Ms Anita Gardner
Principal Planner
Directorate of Place
Arun District Council
Arun Civic Centre
Maltravers Road
Littlehampton, BN17 5LF

Objection to K/7/19/PL – Replacement dwelling at 'Little Deerswood'

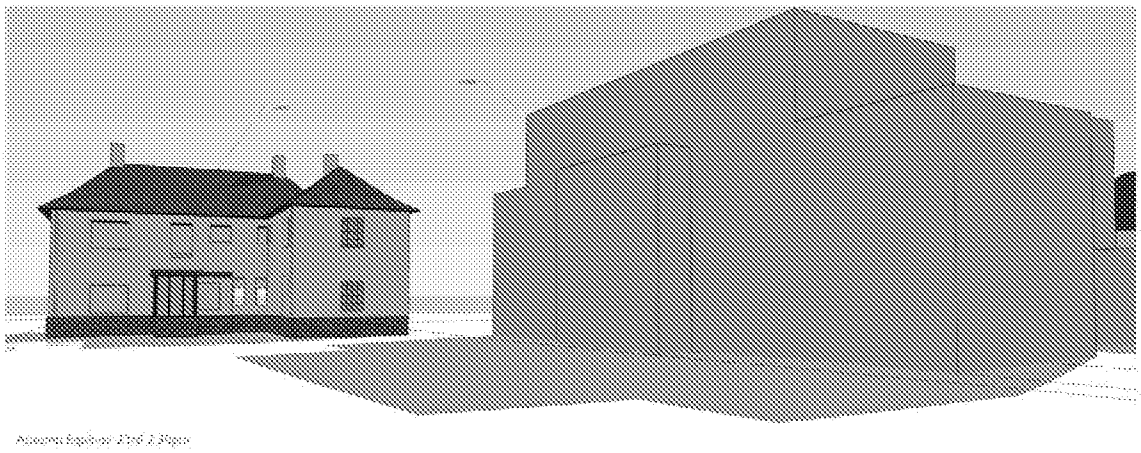
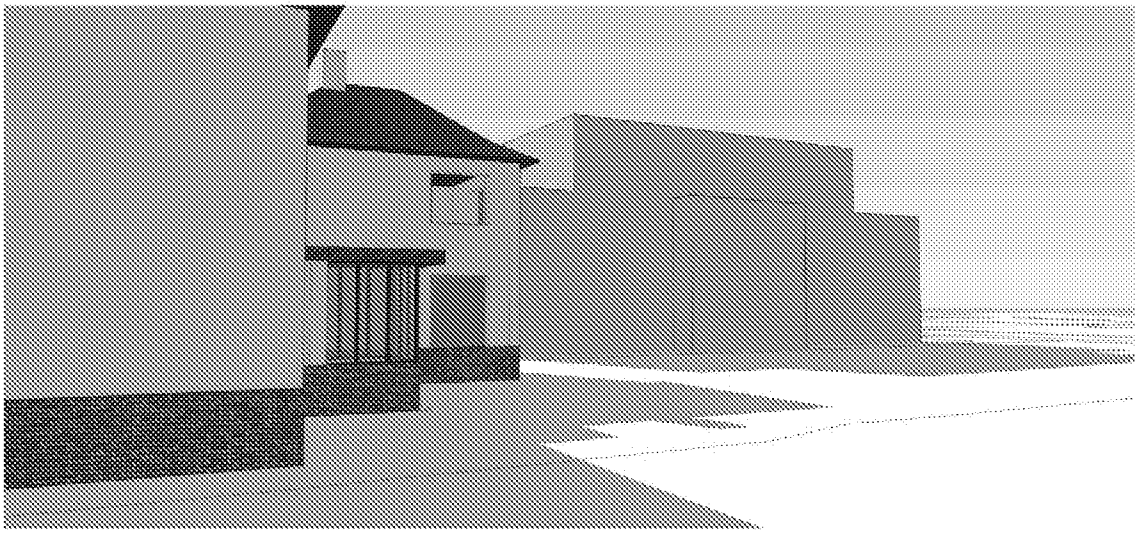
The images below show the true impact of the proposal from Spring Tide using surveyed heights from the application drawings. The ridge line of Spring Tide is +14.065. The parapet height of the proposed development at Little Deerswood is +14.900.

The application proposes a grossly oversized 3 storey bulk set up against the boundary with Spring Tide and stretching for two-thirds of the length of its garden. The impact this will have on Spring Tide is clearly demonstrated by the above images which are a true and accurate representation of the relationship between the 2 properties.

This is a highly inappropriate form of development which will have an acutely adverse impact on Spring Tide. The proposal will have a heavily overbearing presence on the plot and will completely overshadow almost two-thirds of the garden from 2pm onwards for 6 months of the year.

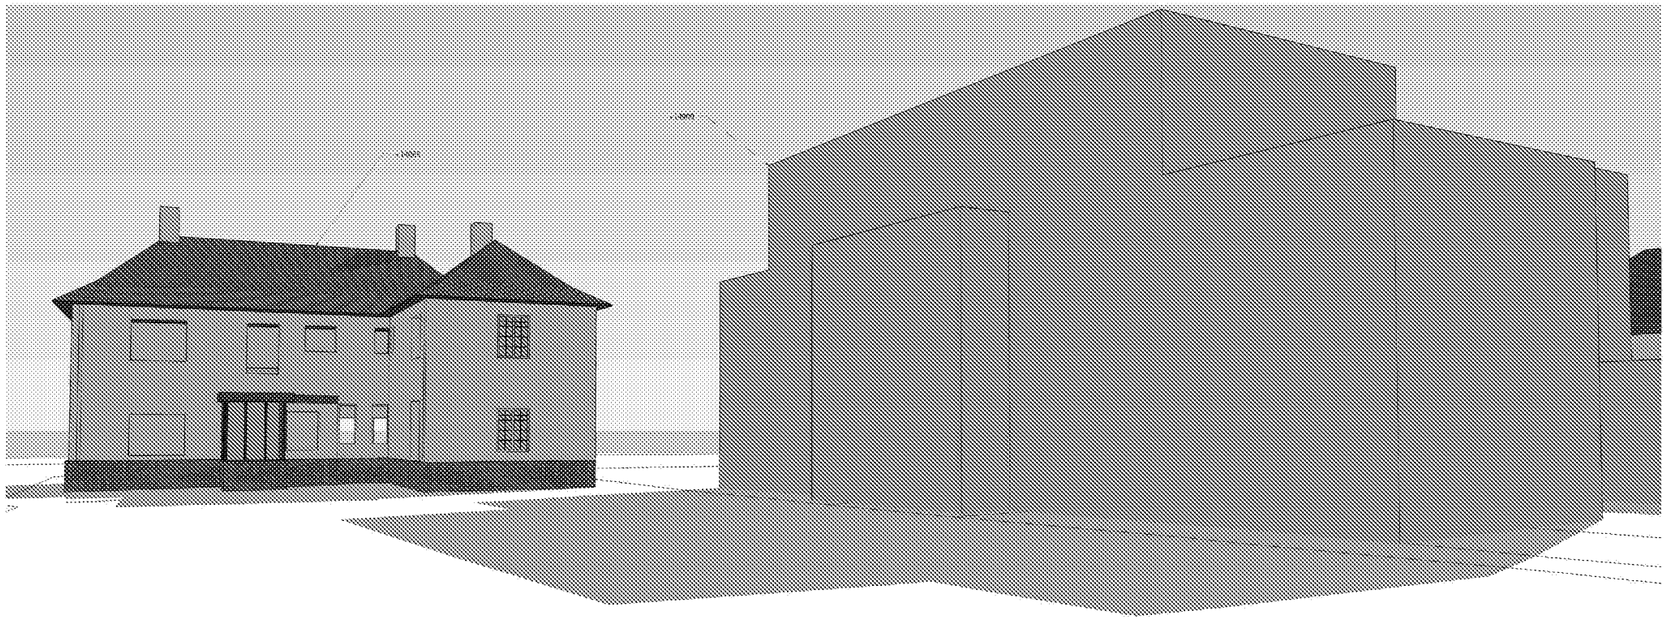
The image above shows the shadow cast by the proposal at 2.30pm during the Equinox
